August 31, 2021

Subject: Approval to Manage Contaminated Soil On-Site Under NR 718.12  
Amoco Oil Terminal Site, Winter Street, Superior, Wisconsin  
DNR BRRTS Activity #s 02-16-000331, 07-16-563483, 07-16-583046  
FID #816009920

August 31, 2021  
Cory Hart  
Amoco Oil Terminal/FedEx Facility  
Superior, WI

FIGURE  
 2

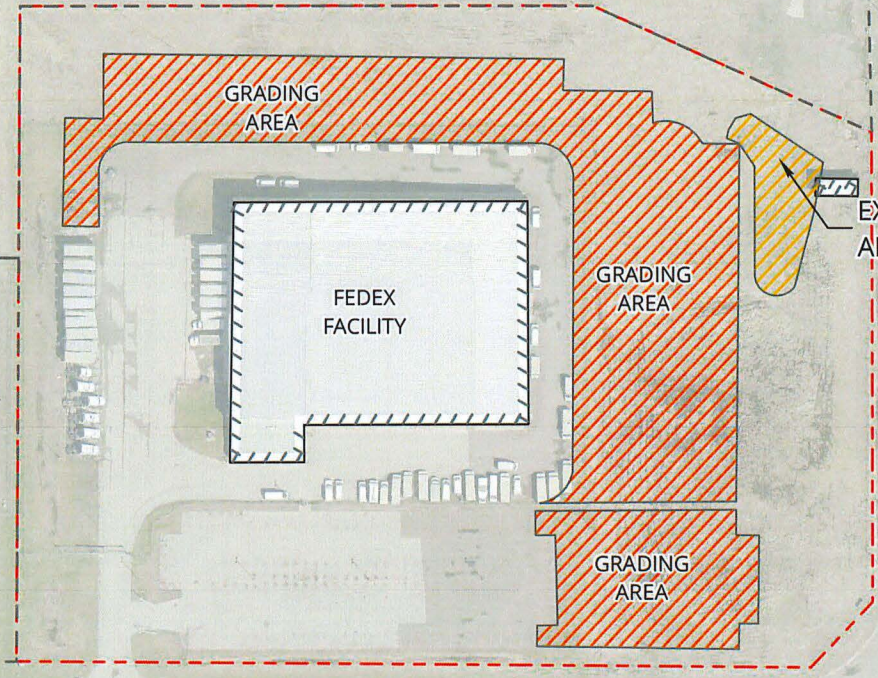
The locations where contaminated soil is proposed to be managed at Amoco Oil Terminal - FedEx Facility is depicted on the attached Figure 2, *Excess Soil Generation Locations*, dated August 24, 2021 by the BBJ Group and Figure 3, *Engineered Barriers, Dry Stormwater Pond and Soil Berm Location*.

FIGURE  
3

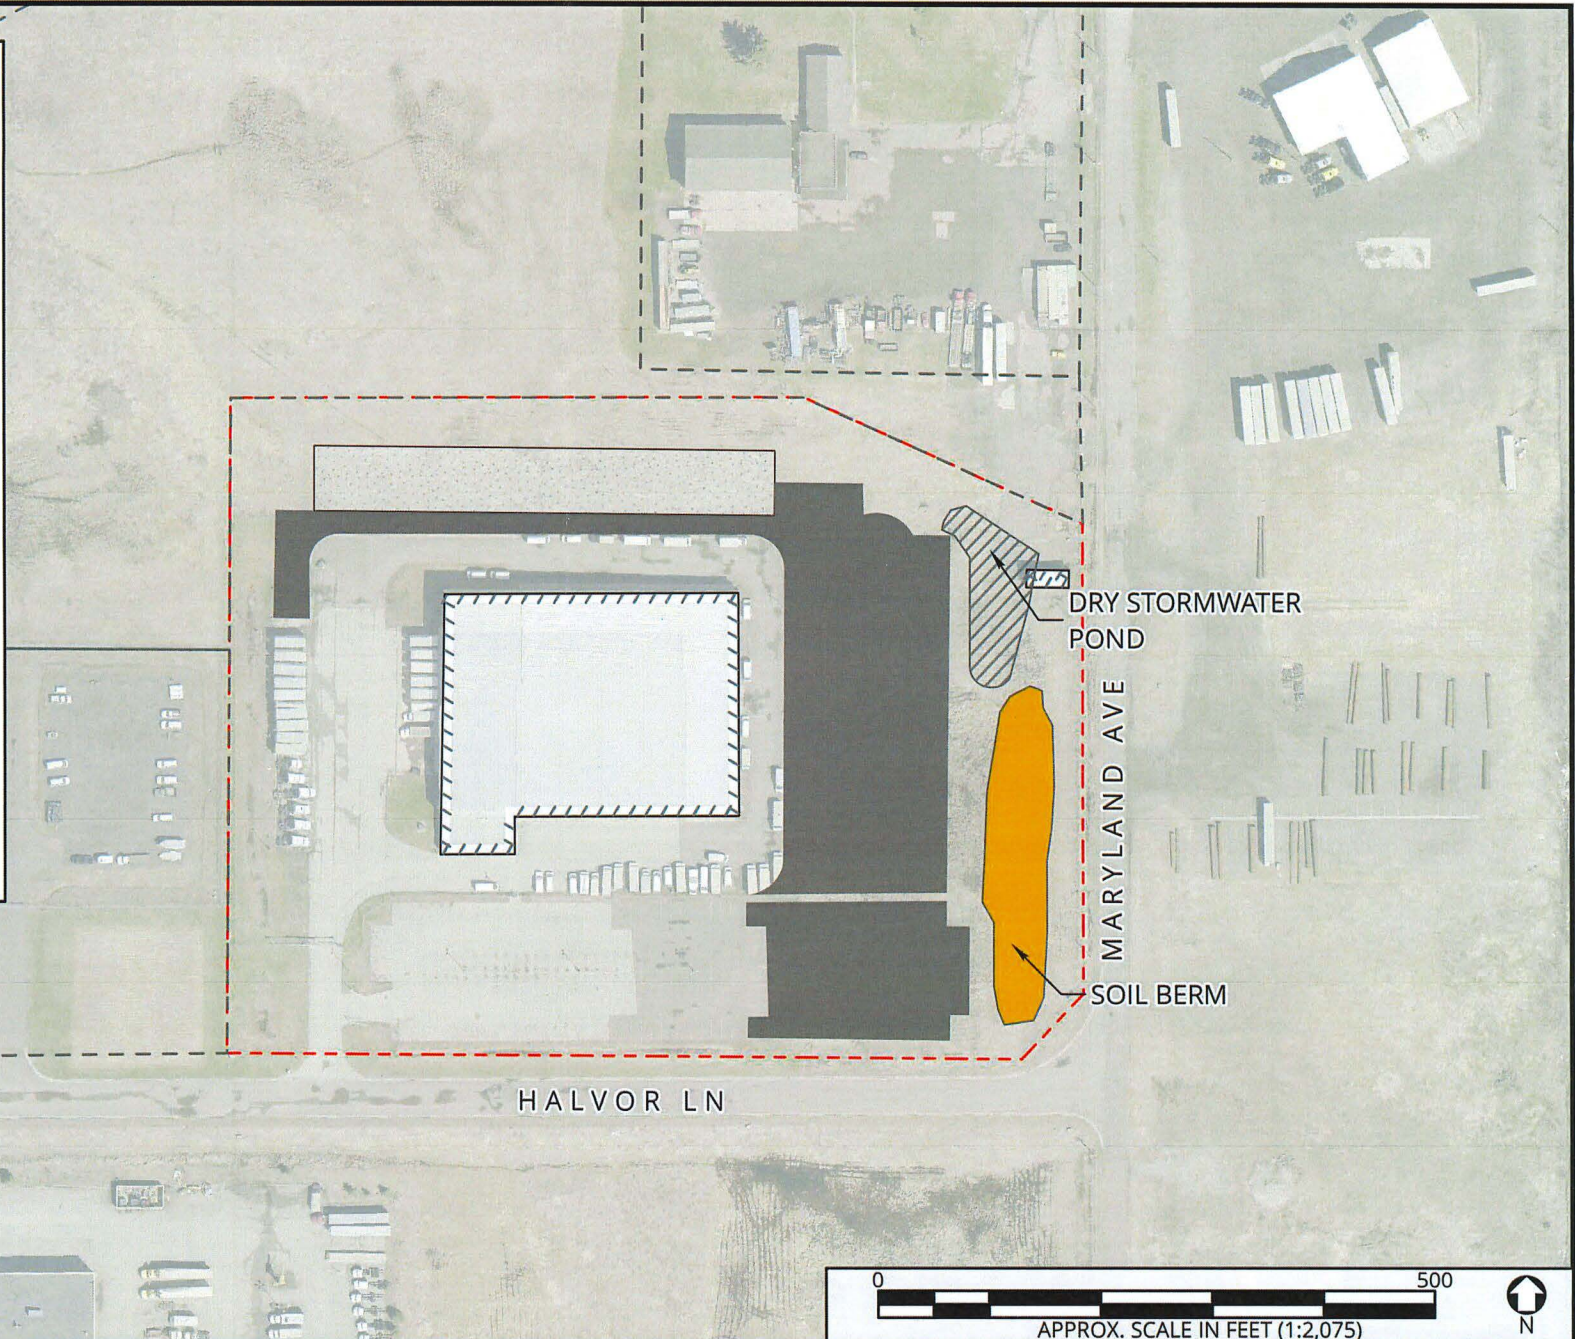
Managing contaminated soil in areas of the Amoco Oil Terminal – FedEx Facility identified on Figure 3 of the MMP, *Engineered Barriers, Dry Stormwater Pond and Soil Berm Location*, dated August 24, 2021 by the BBJ Group, will meet the locational criteria listed under Wis. Admin. Code § NR 718.12 (1) (c).

Known soil contamination will remain under the areas of soil cover as indicated on the attached Figure 3, *Engineered Barriers, Dry Stormwater Pond and Soil Berm Location*. If soil in the locations shown on the map is excavated in the future, the property owner or right of way holder at the time of excavation must sample and analyze the excavated soil. If sampling confirms that

A map is attached, Figure 3, *Engineered Barriers, Dry Stormwater Pond and Soil Berm Location*, which shows where contaminated soil is proposed to be managed and the extent of the proposed covers. Once constructed, inspections of the engineered covers will be required per Wis. Admin. Code § NR 724.13), and submittal of inspection reports may also be required per Wis. Admin. Code § 727.05 (1) (b) 3. Notification to the DNR is required before changing to a non-industrial use if the cover is approved for industrial land use, per Wis. Admin. Code § NR 727.07 (3) to ensure that the cover will be protective for that use.
